Subject: FW: Series 4 - FLIK @ Oakwood school - McBride - Due
From: Jill Hundley <jhundley@vollrathco.com>
Date: 4/28/2021, 1:34 PM
To: David Bethel <ddb@davidbethel.com>

OAKWOOD SCHOOL - JILL HUNDLEY - OAKWD
VL-OAKWD : OAKWOOD SCHOOL
+++++

Subject: RE: OAKWOOD SCHOOL - VL-OAKWD - Release # 3

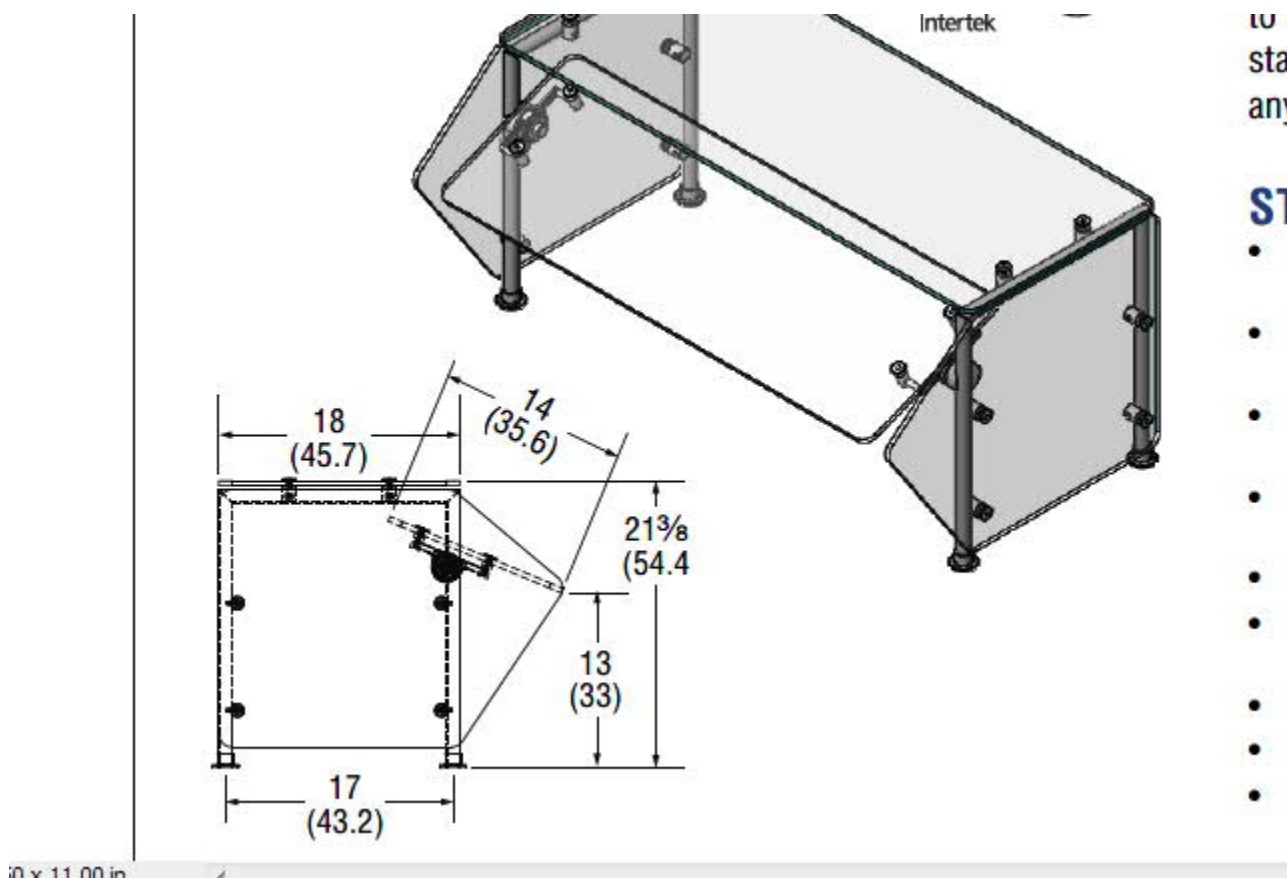
I just realized the end glass you have drawn is for the "C" cafeteria model – the "S" model gets the 5 sided glass –

Could you update.
